UNITED STATES
DEPARTMENT OF THE INTERIOR
BUREAU OF LAND MANAGEMENT
APPLICATION FOR PERMIT TO DRILL OR REENTER

API Number 30-015- 48744	Pool Code 97860	Pool Name JENNINGS; BONE SPRING, WEST
Property Code 331221	Property Name PHANTOM DRAW 20 FED UNIT	Well Number 208H
OGRID No. 7377	Operator Name EOG RESOURCES, INC.	Elevation 3183'

**EOG RESOURCES, INC.
PHANTOM DRAW 20 FED UNIT #208H**

**PECOS DISTRICT
DRILLING CONDITIONS OF APPROVAL**

Proposed Wellbore

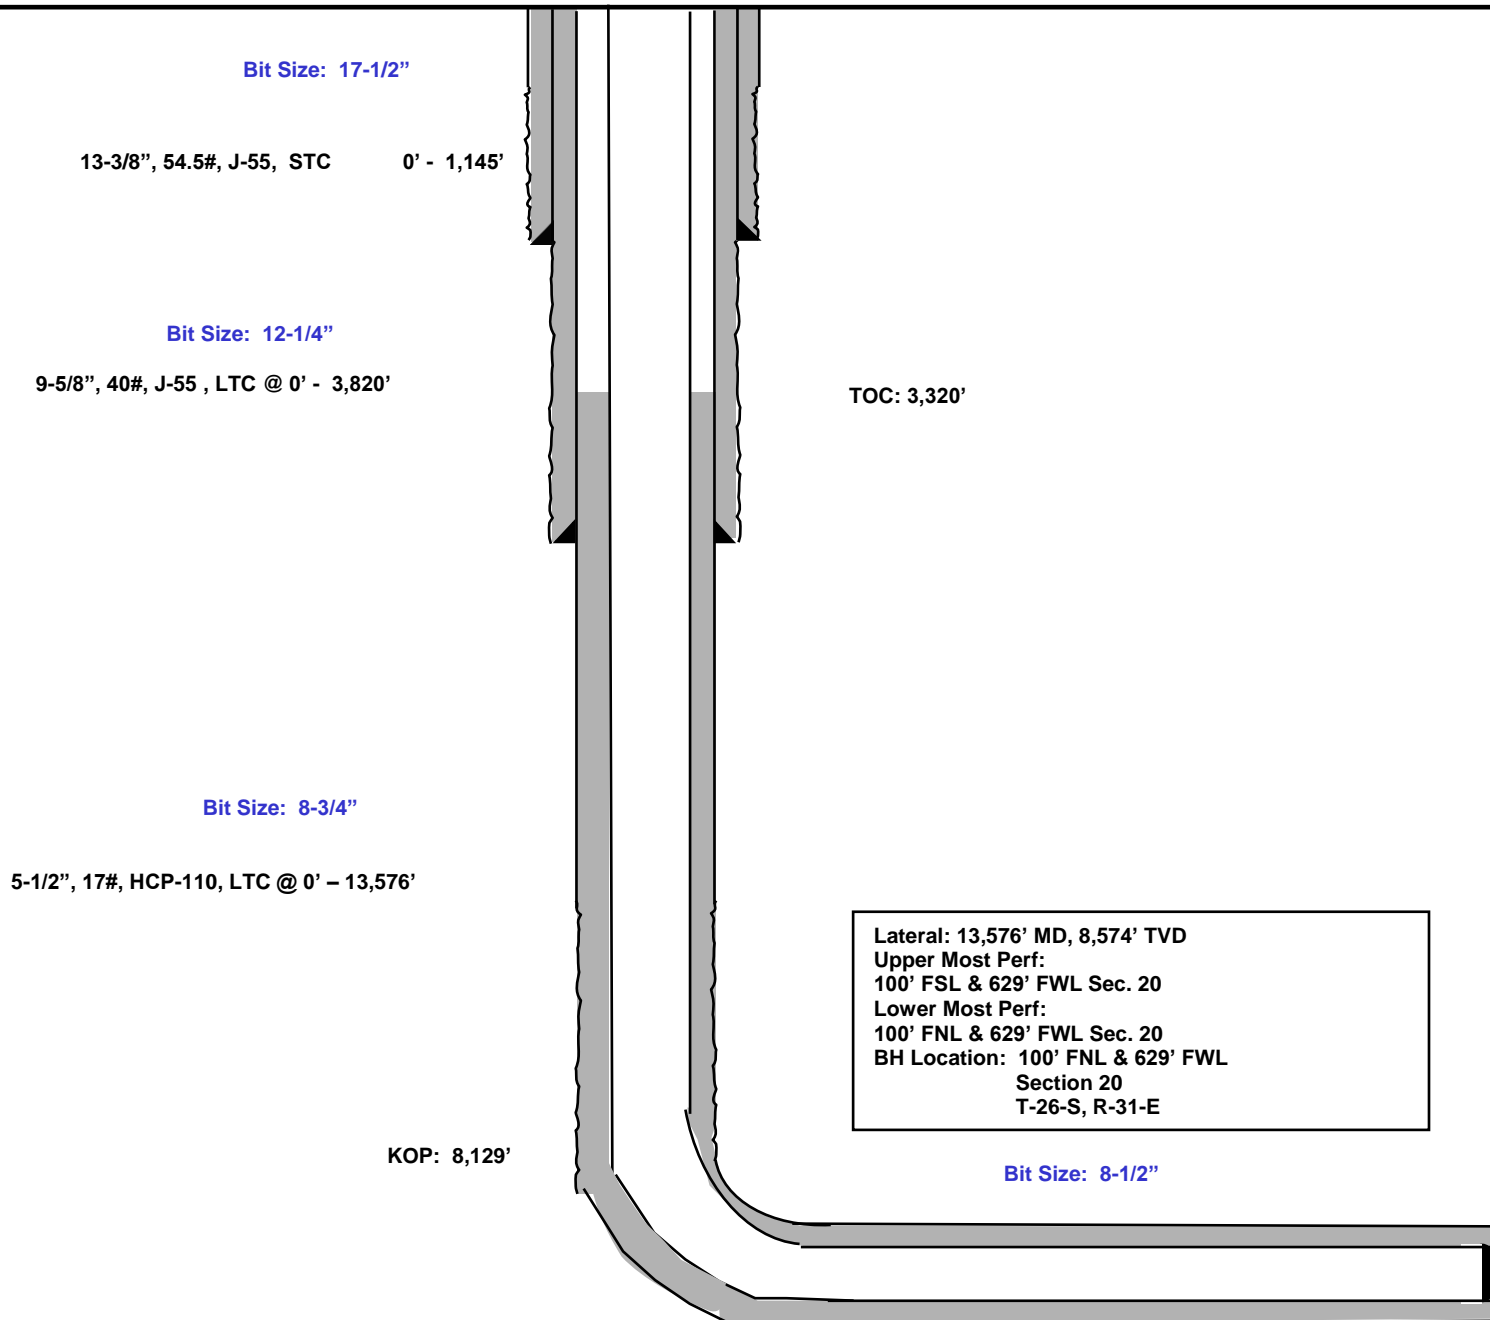
1. The **13-3/8** inch surface casing shall be set at approximately **1,145** feet (a minimum of **25 feet (Lea County)** into the Rustler Anhydrite and above the salt) and cemented to the surface.
 - a. If cement does not circulate to the surface, the appropriate BLM office shall be notified and a temperature survey utilizing an electronic type temperature survey with surface log readout will be used or a cement bond log shall be run to verify the top of the cement. Temperature survey will be run a minimum of six hours after pumping cement and ideally between 8-10 hours after completing the cement job.

3. The minimum required fill of cement behind the **5-1/2** inch production casing is:
 - Cement should tie-back at least **200 feet** into previous casing string. Operator shall provide method of verification. **Excess cement calculates to 23%, additional cement might be required.**
